Access Compliance Report

Public Rights-of-Way

Intersection ID: 28002	Main Street: COLONIAL_COUNTRY_LN	Cross Street: OLD_TAYPORT_PL	Location: SE
ADA ID: 6F1F039BC3F8	Ramp Type: PerpDiag	Initial Pass/Fail: Fail	Overall Compliance: No
Severity Score: 13.75			
Codes/Mitigation Info/Possible Solution		Field Measurements/Component Compliance

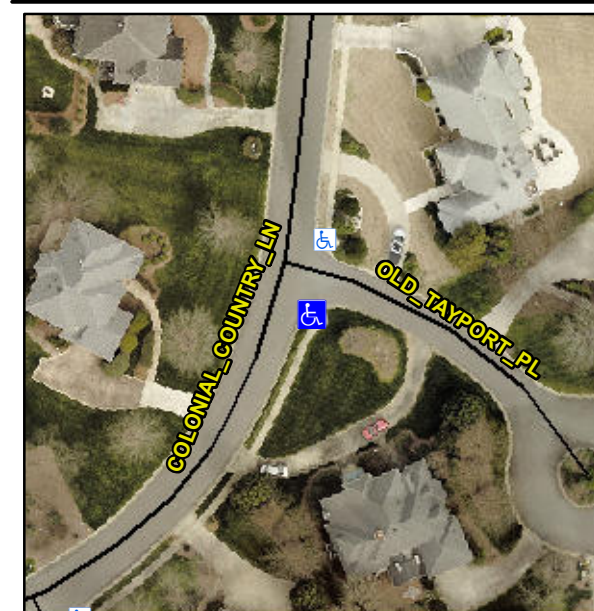
Not Found, R304.2.2, R304.5.3

Compliance	Description	Data	Compliance	Description	Data
N/A	Ramp Length (in)	96.0	No	Ramp Slope (%)	8.6
Yes	Ramp Width (in)	49.0	No	Ramp XSlope (%)	2.2
N/A	Flare Type LT	N/A	N/A	Flare Type RT	N/A
N/A	Flare Slope LT (%)	N/A	N/A	Flare Slope RT (%)	N/A
N/A	Flare Traversable LT?	N/A	N/A	Flare Traversable RT?	N/A
N/A	Landing Length (in)	N/A	N/A	DWS Provided?	N/A
N/A	Landing Width (in)	N/A	N/A	DWS Contrast?	N/A
N/A	Landing Slope (%)	N/A	N/A	DWS Length (in)	N/A
N/A	Landing X Slope (%)	N/A	N/A	DWS Full Width?	N/A
N/A	Landing Curb? (Y/N)	N/A	N/A	DWS Offset (in)	N/A
N/A	Shared Landing?	N/A			
N/A	Gutter Ponding?	N/A	N/A	Gutter Slope (%)	N/A
N/A	Gutter Lip Ht (in)	N/A	N/A	Gutter X Slope (%)	N/A
N/A	Painted X Walk1?	No	N/A	Painted X Walk2?	No
	X Walk 1 Direction	To NE		X Walk 2 Direction	To NW
N/A	X Walk 1 Width (in)	N/A	N/A	X Walk 2 Width (in)	N/A
	X Walk 1 Slope (%)	0.1		X Walk 2 Slope (%)	4.0
	X Walk 1 X Slope (%)	1.9		X Walk 2 X Slope (%)	1.7

Remove & Replace Curb Ramp With Two New Directional Ramps or Equivalent.
